**E4419B-19A**

**S E R V I C E N O T E**

**Agilent E4418/19 EPM Peak & Average Power Meter**

**Hot plugging problem Caused by Intersil component part number – MPN DG411DY**

Fig 1: Measurement Board, A3

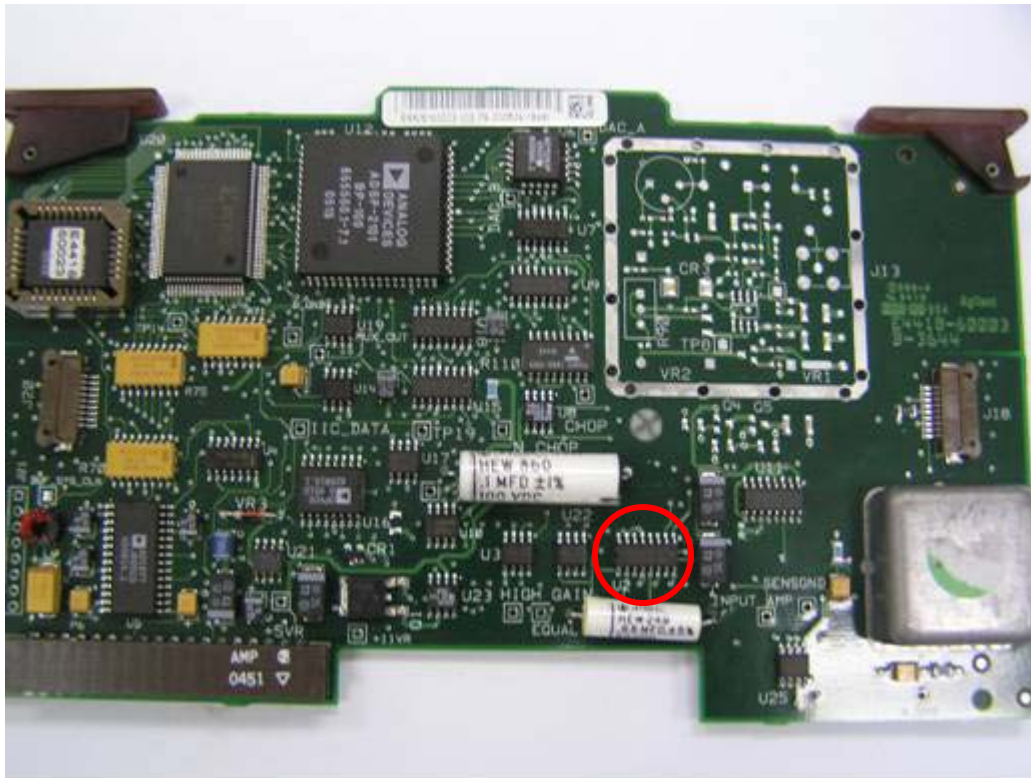
1.) This is a measurement board, E4418-60003 or A3 shown in figure 1.

**Fig 2: Intersil Component, DG411DY**

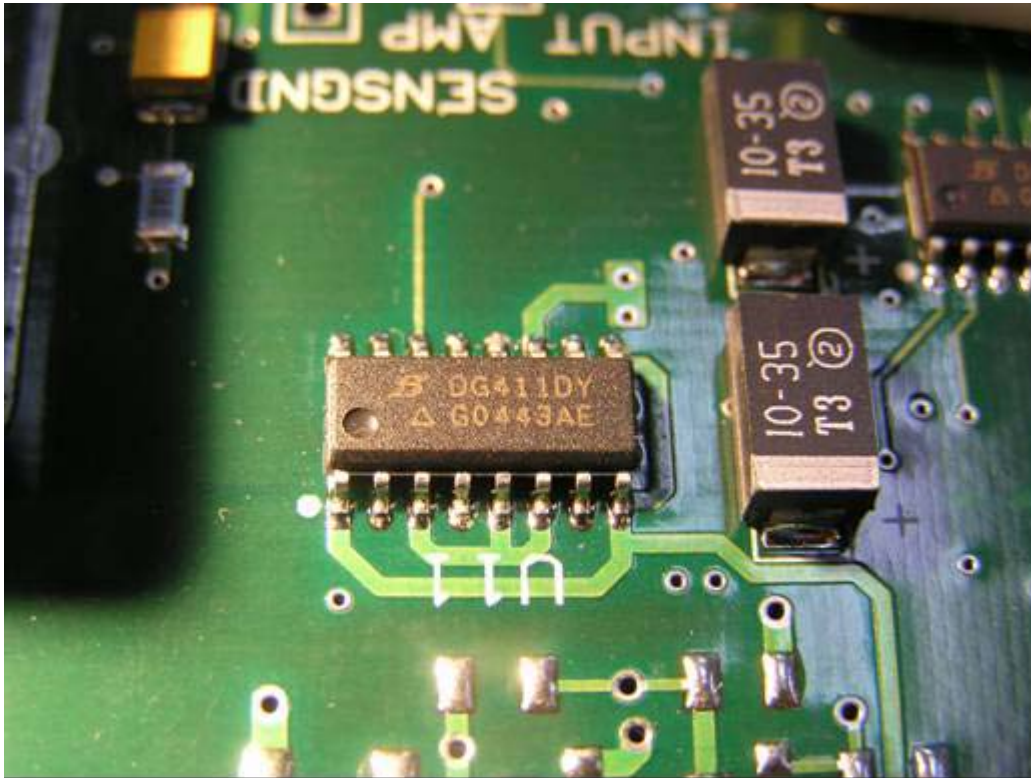
From the studies has been found that only the component supplied from **Intersil** brand is contributed to hot plugging problem. This analog switch component with part number DG411DY printed on the IC component indicating it is Intersil brand.

- 2.) The figure 2 will be zooming to measurement board, A3 with Intersil supplier (U11) analog switch component.

The problematic measurement board will be encouraged to be replaced by good measurement board which consists **without** of (U11) analog switch component of Intersil brand (marked with DG411DY) and shown in figure 2 below.

**Figure 3: No Sensor Detected while  
Sensor is connecting**

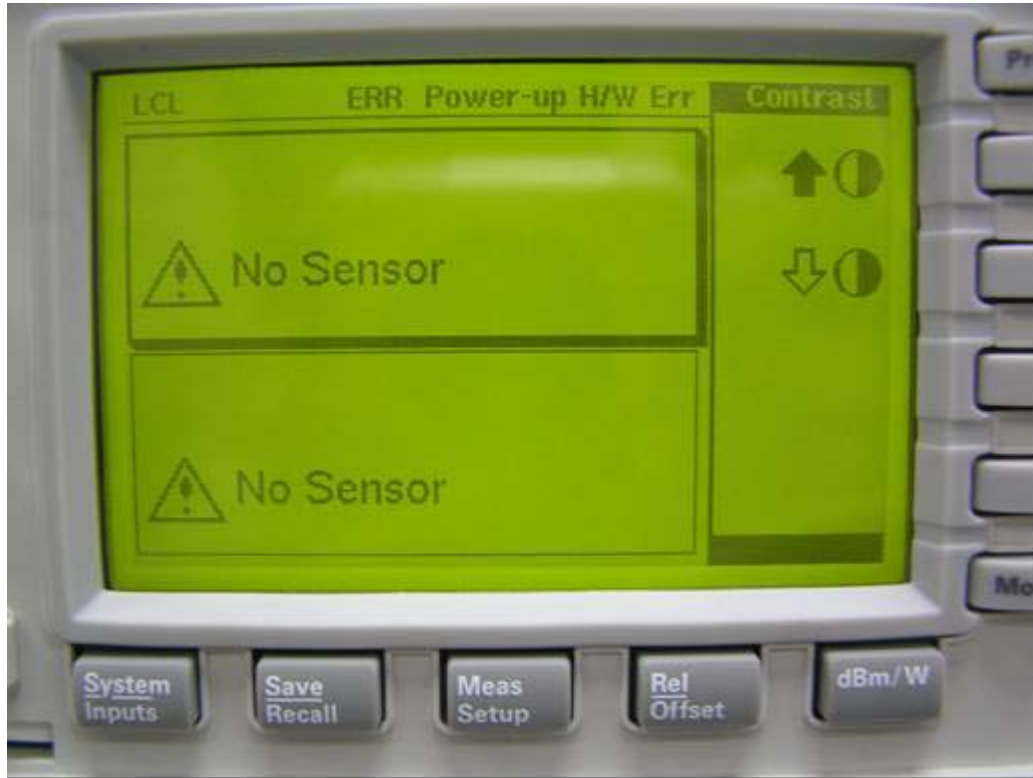
This problem happened on power meter, E441x when the front panel power Off/On switch turned on first and direct plug out the power cord from the meter and on it back. Then the power meter will be hung up from time to time and an error message will be displayed and shown in figure 3 below. To get the power meter in operation mode again the system operator needs to manually PRESET the power meter.

The problematic measurement board will be shown no sensor in figure 3. Mean time, the function/good measurement board would show sensor detected in figure 4 below.
